Re: **Dr. Joseph G. Perrault House**
235 Lake Street
St. Albans, Franklin County, Vermont

Adaptive re-use rehabilitation – application for VCDP funding

This letter report and request for Section 106 review is the follow up to the Determination of Eligibility and is intended to provide information about the condition of the building and its components, proposed scope of rehabilitation work, as well as preservation analysis. This letter provides recommendations for a determination of effect for the schematic plans proposed in anticipation of a VCDP application for funding and potentially other state and federal sources to be identified in the future. **A future phase of the project is also presented and reviewed here because it will be applying for VCDP funds as well.**

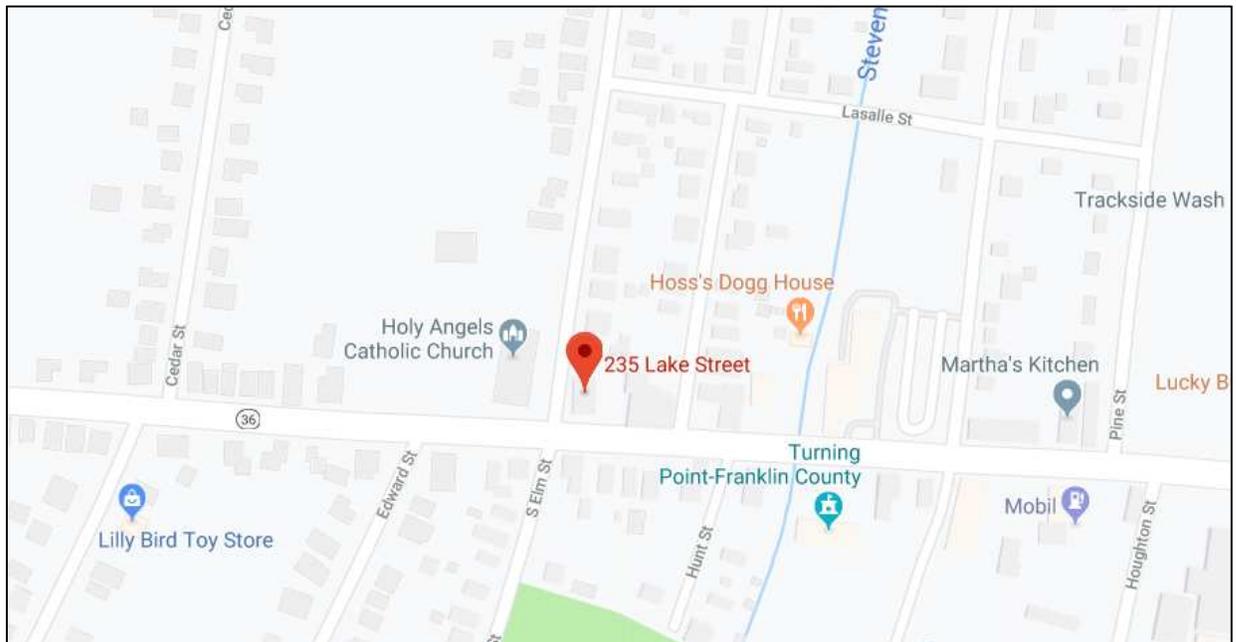
Left: Detail of 1912 Sanborn Map (Sheet 9) showing previous dwelling on site with shed and small barn and very small dwelling (“#233 1/2”) at northeast (rear) corner of lot;

Center: Detail of 1920 Sanborn Map (Sheet 2) showing present house built next to previous house and what appears to be new 2-story barn with tiny shed attached in location of earlier collection of small structures (northeast corner);

Right: Detail of 1926 Sanborn Map (Sheet 8) showing removal of earlier house on lot, conversion of barn into garage and addition of 1 story wing that protrudes beyond façade of barn/garage and the construction of a duplex fronting North Elm Street at northwest (rear) corner of lot. Note: No change is shown on the 1946 update of the 1920 Sanborn Map

The extant 2-story gable-roofed portion of the barn/garage was constructed between 1912 and 1920 but likely at the time of the present house which is c. 1915. The barn was converted to a garage by 1926 when a one story wing was added and a residential duplex was added to the lot fronting on North Elm Street. Sometime after 1946 the duplex was removed and the barn/garage structure further altered when the protruding front of the 1 story wing was cut back and three overhead garage doors were installed across the new flush facades. In the last 30 years or so the structures, like the house, were covered in vinyl siding. The location of the demolished c. 1925 duplex is the location of the present fenced playground. The barn/garage structure has been altered considerably, appears to have low architectural integrity and is in poor condition. Based on these factors, I recommend that it be considered **non-contributing to the potential historic district**. Its major alterations also occurred after the death of Dr. Perrault which diminishes any potential criterion B significance.

Left: Detail of existing 1st fl. plan of northwest rear room with area to be removed in red circle including toilet, closet and chimney; Right: Detail of proposed 1st fl. plan of same area

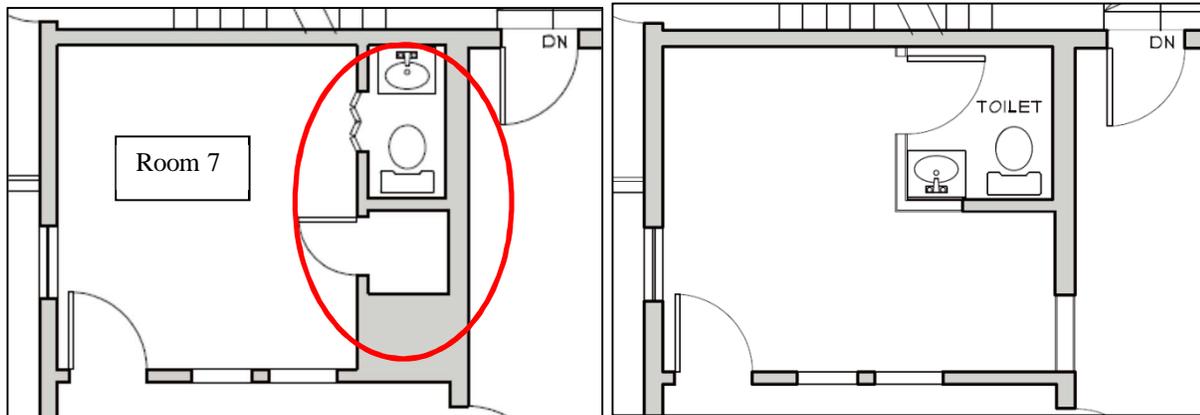
On the first floor, the existing floor plan and historic features and finishes will all be preserved as is with one exception in the rearmost (northwestern) corner room. In that room, where a modern powder room had been added, the powder room and adjacent closet will be removed and a larger restroom for staff will be built in the northeast corner of the room. The exterior window and historic door to the next room on the south will be preserved as will a non-historic double opening in the wall between these rooms.

Left: 15) 2nd fl. Room 4, looking southwest; Center: 16) 2nd fl. center bath, looking south; Right: 17) 2nd fl. Room 6, looking south at closet to be removed

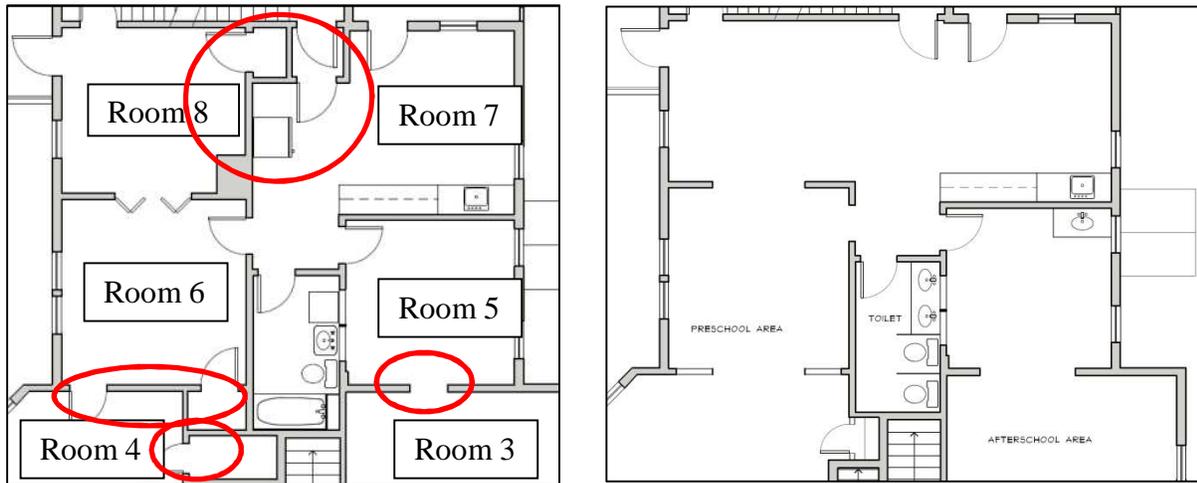
In the southeast room (room 1) the doorway will be in a new wall at the end of the landing hall and three closets will be removed so that the room can open into the room to its north on the east side. In addition, the two rooms centered on the east side will have the present door opening between them expanded for a larger framed opening so the three rooms on that side can function as one classroom. The landing doorway into the southwest room (room 2) will be pulled back from its present location to allow for a current closet door to once again serve as a door into the rear section on the west side.

Left: Detail of existing 2nd fl. plan: rear four rooms (north is at top);
Right: Detail of proposed 2nd fl. plan rear four rooms. Note circled walls/doors to be removed.

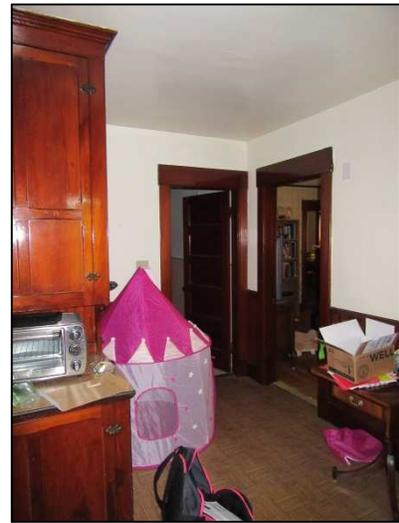
The two rooms centered on the west side (room 4 and room 6) will be slightly reconfigured with removal of three closets to open them up to each other with a new framed opening so they can function as one classroom. A large framed opening between the rear northwest corner room (room 8) and the one to its south (room 6) will be preserved so it can be an extension of the classroom. The kitchen in the northeast corner (room 7) will be expanded by joining it to adjacent room 8 on its west including the removal of a closet and vestibule in its northwest corner and chimney. The historic cabinetry will remain intact. The bathroom in the center of the second floor will not be changed except to add one sink and replace the tub with a second toilet stall. The two historic high borrow-lights in the bathroom's east wall actually have no glazing at present. The window will be re-glazed and preserved.
